**SAN CARLOS AIRPORT RUNWAY 12-30 & CONNECTOR TAXIWAY REHABILITATION  
PROJECT**

**COUNTY PROJECT NO. ASL03  
PROJECT FILE NO. E5077**

**ADDENDUM NO. 2**

GC102(REV 2)  
SHEET 6 OF 53

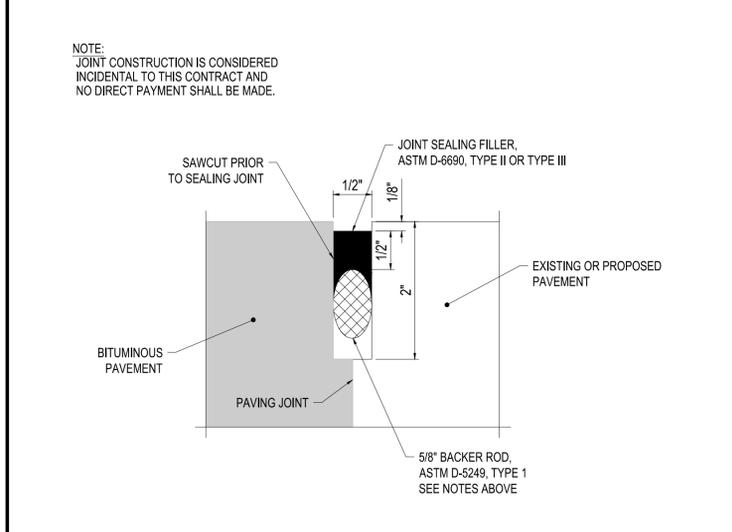
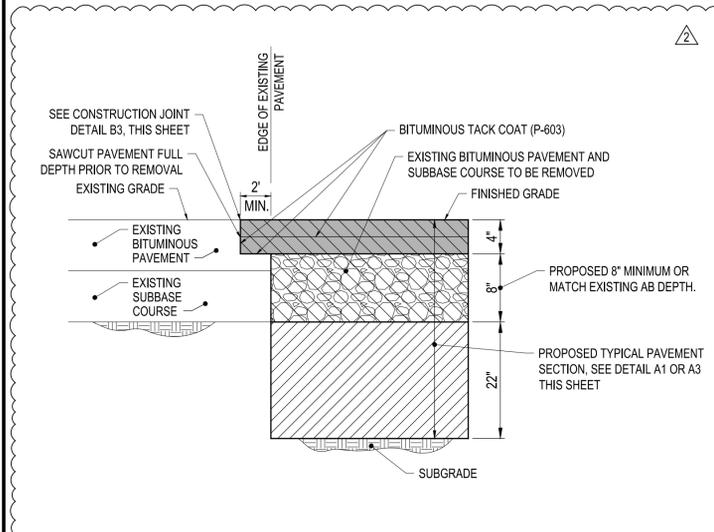
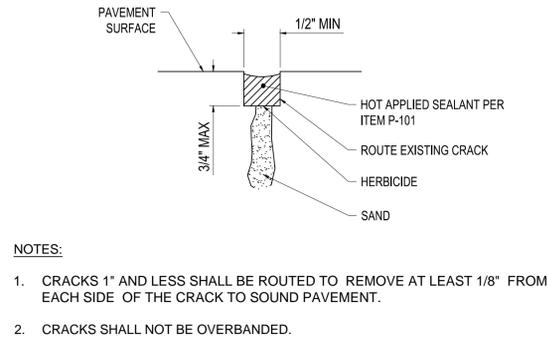
2. A contractors secondary staging area has been added and shown on Plan Sheet GC102. Sheet GC102 shall be replaced in the Project Plans:

**Replace plan sheet GC102 with plan sheet GC102 (rev2).**

**B2** NEW ASPHALT TO EXISTING ASPHALT KEYING DETAIL  
SCALE: NOT TO SCALE

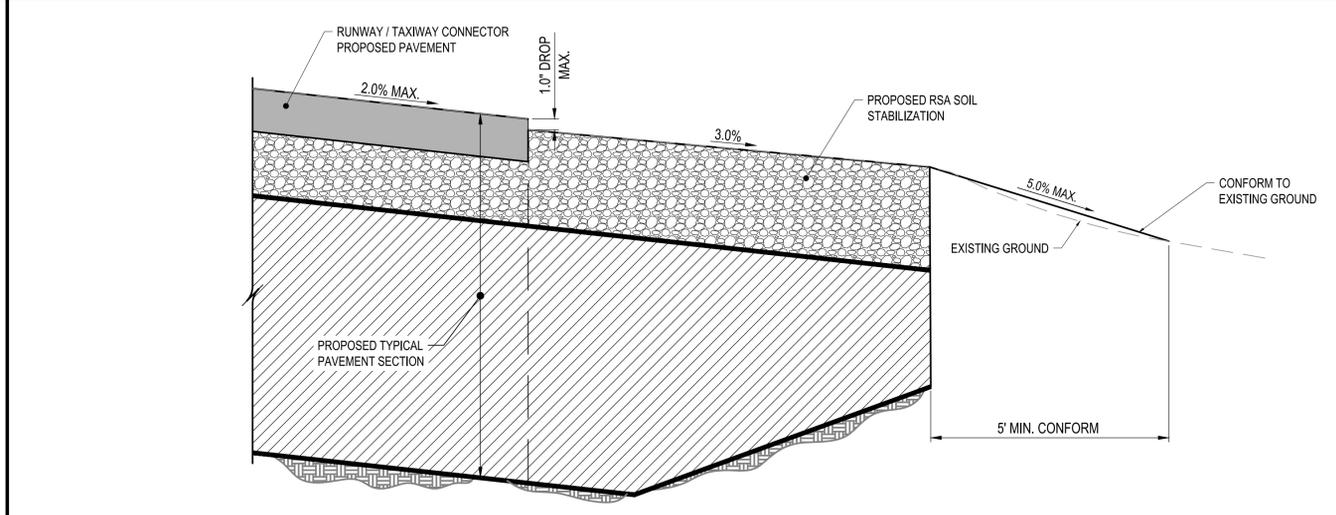
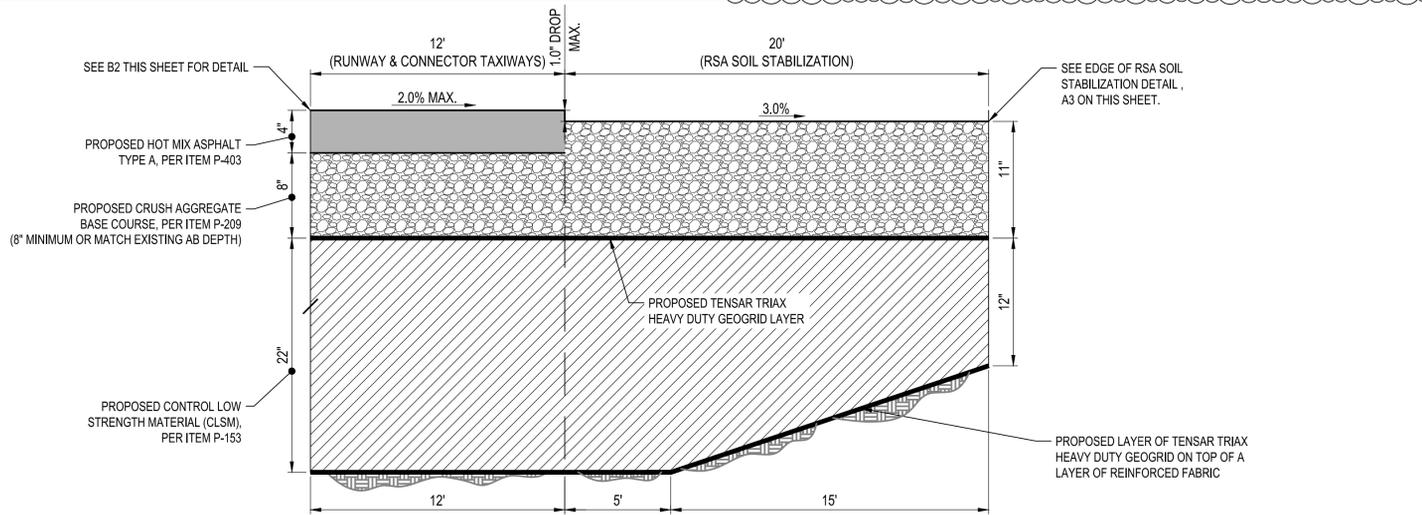
3. Detail B2 on Plan Sheet CP501 has been revised. Sheet CP501 shall be replaced in the Project Plans:

**Replace plan sheet CP501 with plan sheet CP501 (rev2).**
